IN THE MATTER Resource consent applications by Te Puna Industrial
Limited in relation to 297 Te Puna Station Road

**STATEMENT OF EVIDENCE OF TOM WATTS ON BEHALF OF
TE PUNA INDUSTRIAL LIMITED**

(LANDSCAPE AND VISUAL EFFECTS)

25 JUNE 2024

Figure 1. Screenshot from Landscape Plan 'Permitted Works Boundary Landscaping (dated 10 August 2023) showing dimension and 5 x rows.

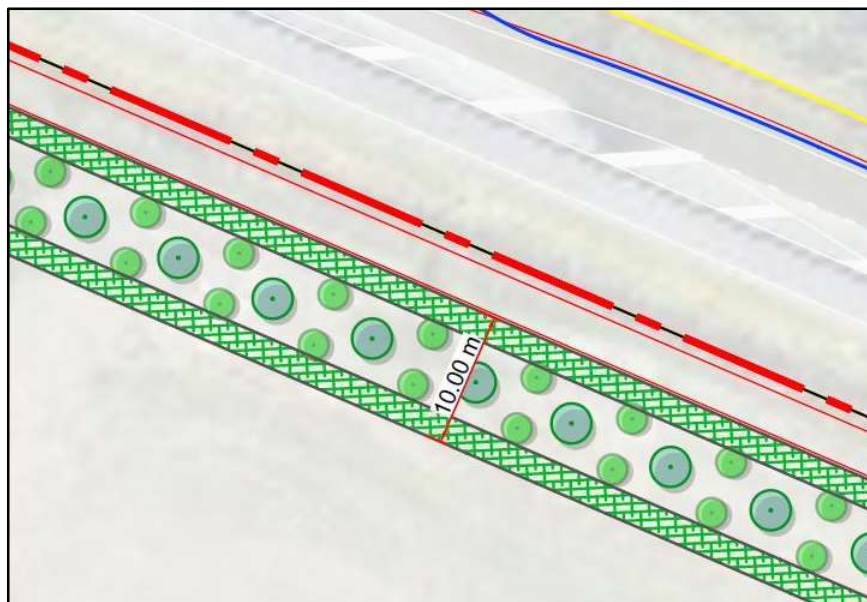
- 10.5 Width of the perimeter planting and bunding, and ability to strictly comply with the required 10m width and 5 planted rows required by the Structure Plan.

- 10.18 Mr Mansergh raised some queries around the precise spacing and dimensions of the perimeter planting and its capacity to meet Structure Plan requirements, and questioned the appropriateness of a select few tree species for screening (Lancewood and NZ Cabbage Tree).²⁰

- 10.21 As it relates to the dimensions and precise spacing of permitter planting, a landscape plan was submitted to the Council to demonstrate compliance on

30 August 2023.²¹ This layout meets the requirements of the Structure Plan (10m wide, 5 x rows), as shown in the screenshot of the landscape plan shown below (crosshatching represents the row of native shrubs to the outside of landscaping strip), and will be refined further at detailed design, whilst ensuring compliance with landscaping Structure Plan pre-requisites concerning planting patterns.
